ADDENDUM NO. 1

Date Issued: August 11, 2021

RE: LINDEN ROSELLE SEWERAGE AUTHORITY
Contract Number 61-19
Emergency Generator Switchgear Replacement

PROJECT NO. 5015-239030
 FILE NAME: E012GEEL.DWG
 SHEET NO.
E-12

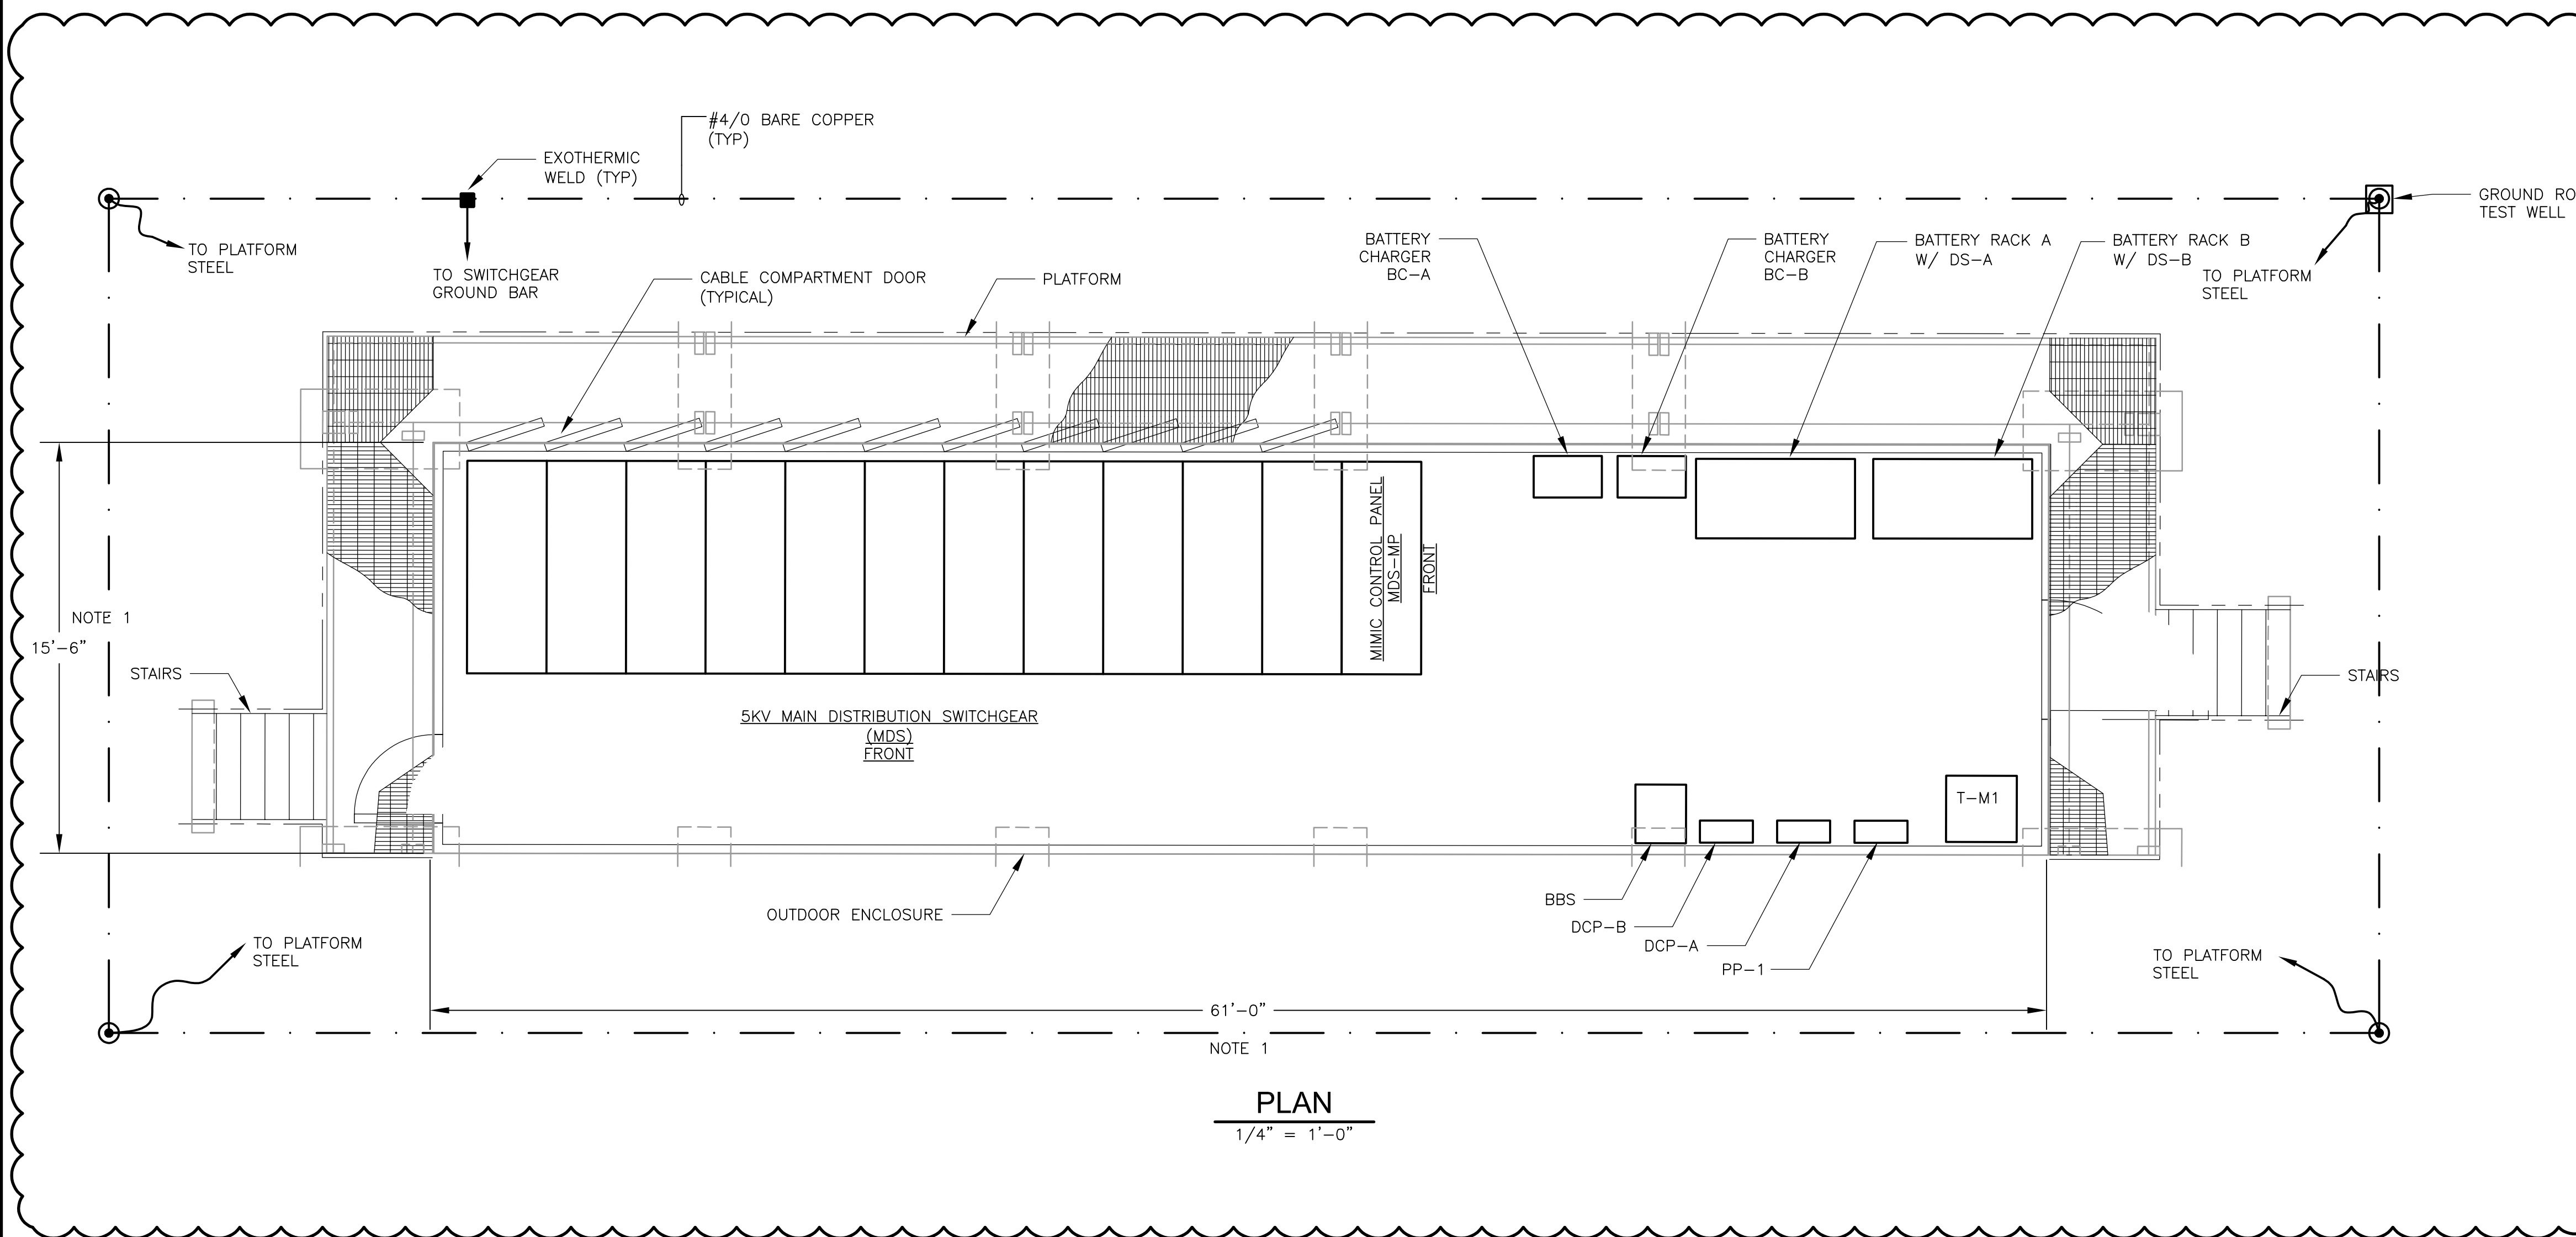
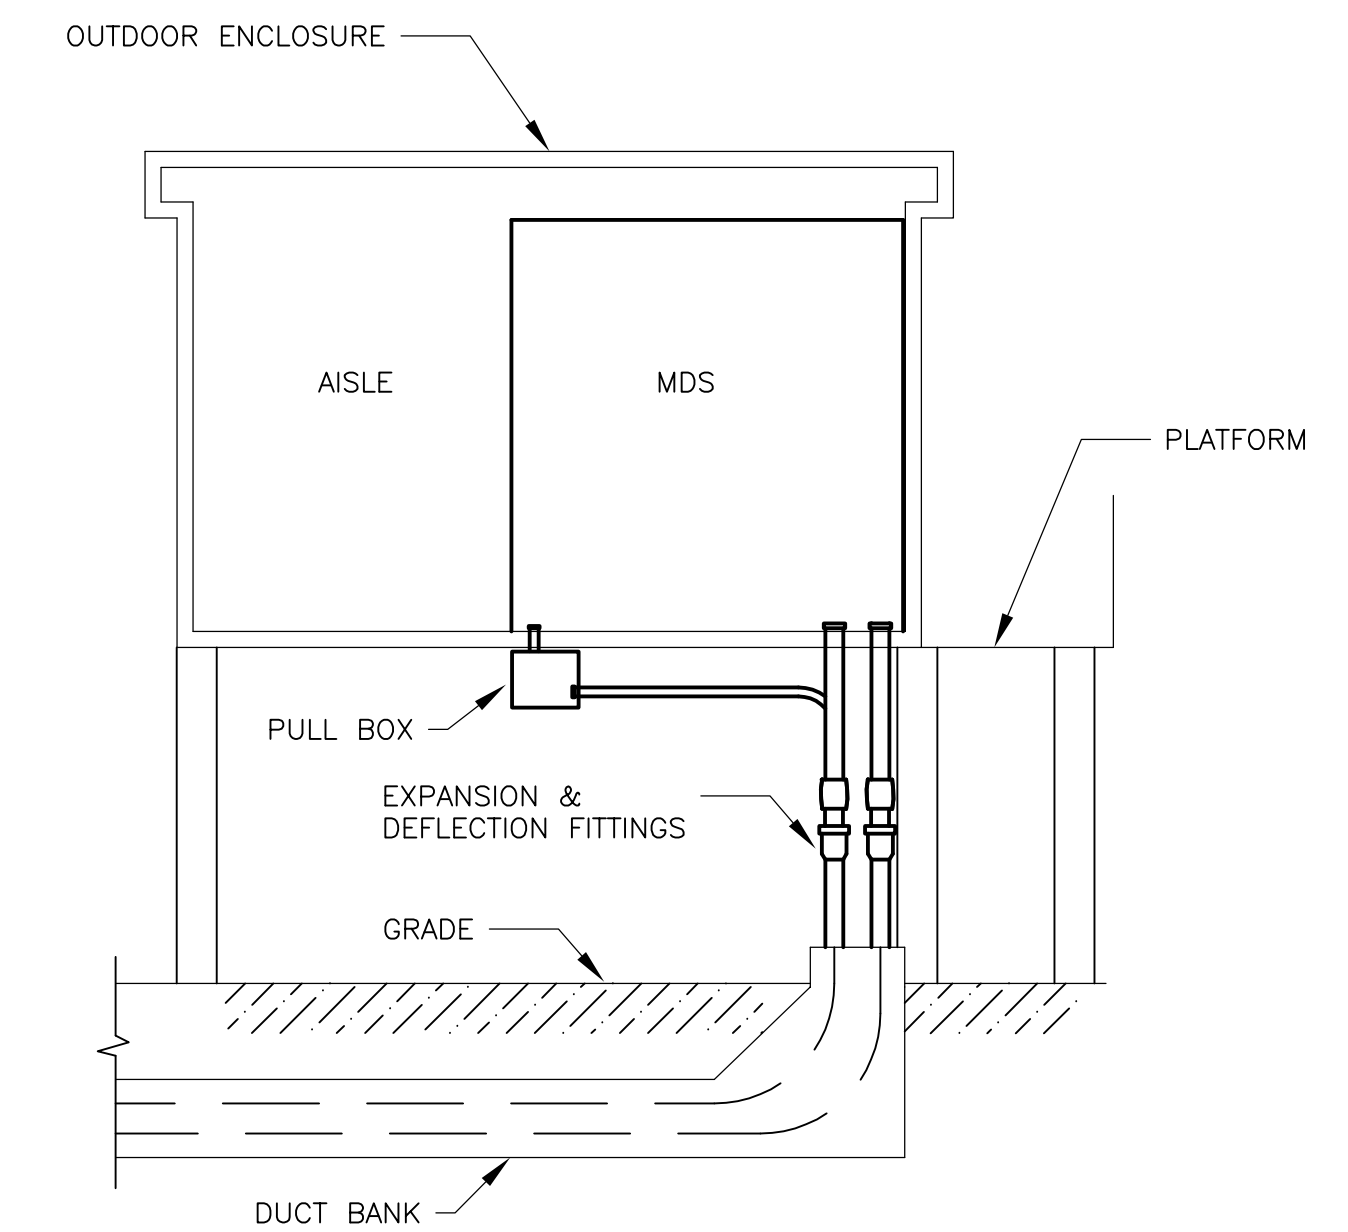
7. QUESTION/COMMENT: It is assumed that the new switchgear/platform/enclosure will be required to be grounded. Please provide drawings/details?

RESPONSE: See Addenda Item #4. Drawing E-12 has been revised.
